# XOMOX

May 3, 1993

**IMPORTANT SAFETY NOTICE**  
**PLEASE READ CAREFULLY**

**Subject:** Cover bolt fracture on Xomox Tufline Plug Valves at New Hampshire Yankee Seabrook Station. Xomox Tufline sleeved plug valve models 066, 067, 0366, 0367, 036, 037, 0336, 0337, 046, 047, 056, 057, 166, 1366, 136, 1336, 027, 0327, 126, 1326, 1626 with SA/A 193 Grade B6 cover bolts are the subject of this notice.

# TYPICAL XOMOX TUFLINE SLEEVE PLUG VALVE SHOWING LOCATION OF COVER BOLTS

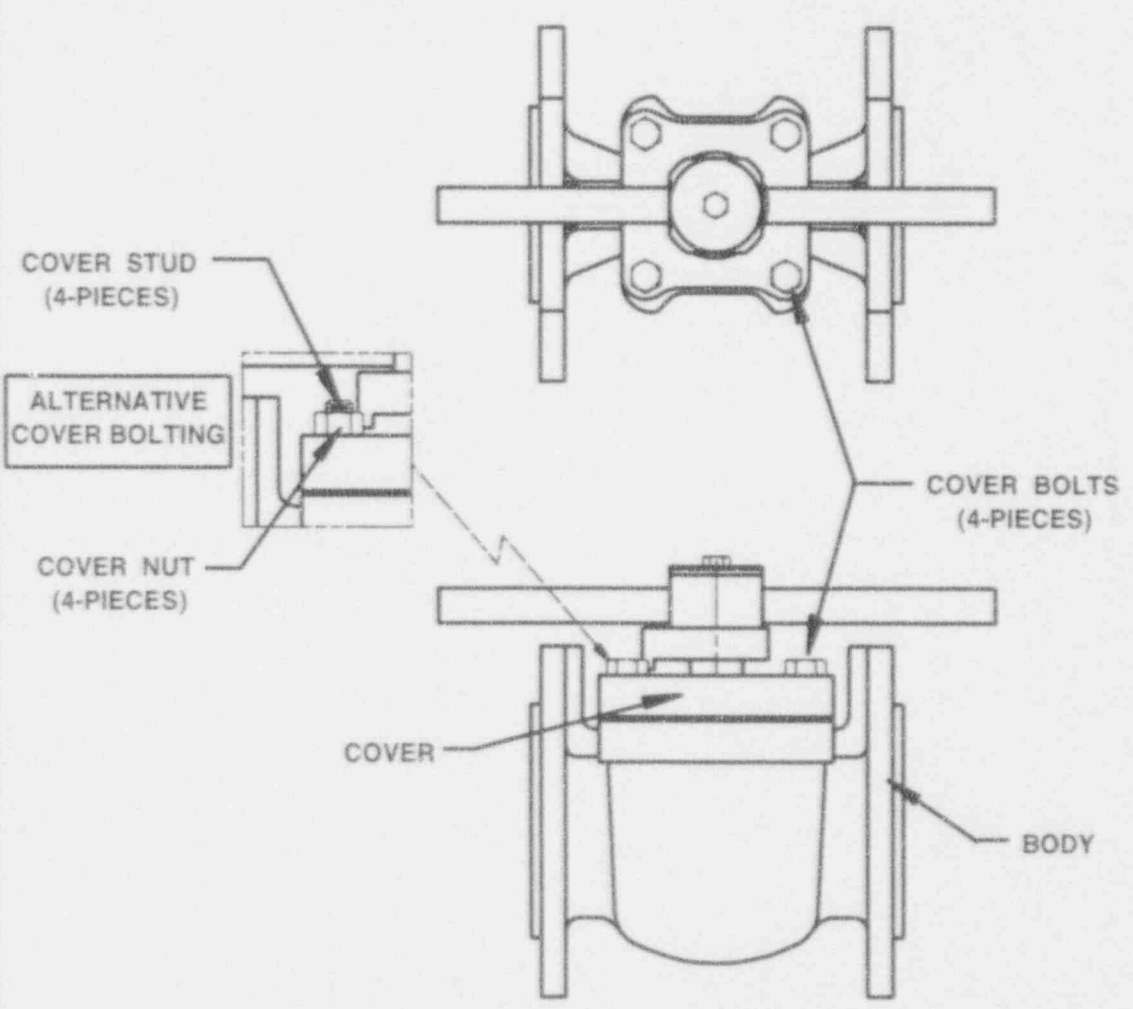
**Purpose:** Xomox is issuing this information notice to alert addressees to problems with SA/A 193 Grade B6 cover bolts on Xomox Tufline plug valves experienced at New Hampshire Yankee-Seabrook Station. It is expected that recipients will review this information for applicability to their facilities and consider actions, as appropriate, to avoid similar problems. *See attached diagram of valve for bolt location.*

**Problem:** In July of 1992 a Xomox Tufline plug valve, supplied in 1981 to New Hampshire Yankee-Seabrook Station, was discovered with 3 of the required 4 cover bolts fractured. Further inspection revealed 2 additional valves, also supplied in 1981, with 2 of the 4 bolts fractured. The cover bolt material, SA/A 193 Grade B6, was supplied in accordance with the design specification for these valves. The SA/A 193 material specification for Grade B6 does not call out maximum hardness and the bolts which fractured had hardness levels averaging 37 Rc. New Hampshire Yankee determined the cause of the fracture to be Intergranular Stress Corrosion Cracking (SCC). New Hampshire Yankee previously communicated this incident through the INPO Nuclear Network System operating experience report OE 5817.

**Action:** New Hampshire Yankee-Seabrook replaced certain installed SA/A 193 Grade B6 cover bolts with SA 564 Type 630 condition H1150 material. Recipients of this notice should conduct their own study and reach their own conclusion regarding appropriate actions to avoid similar problems.
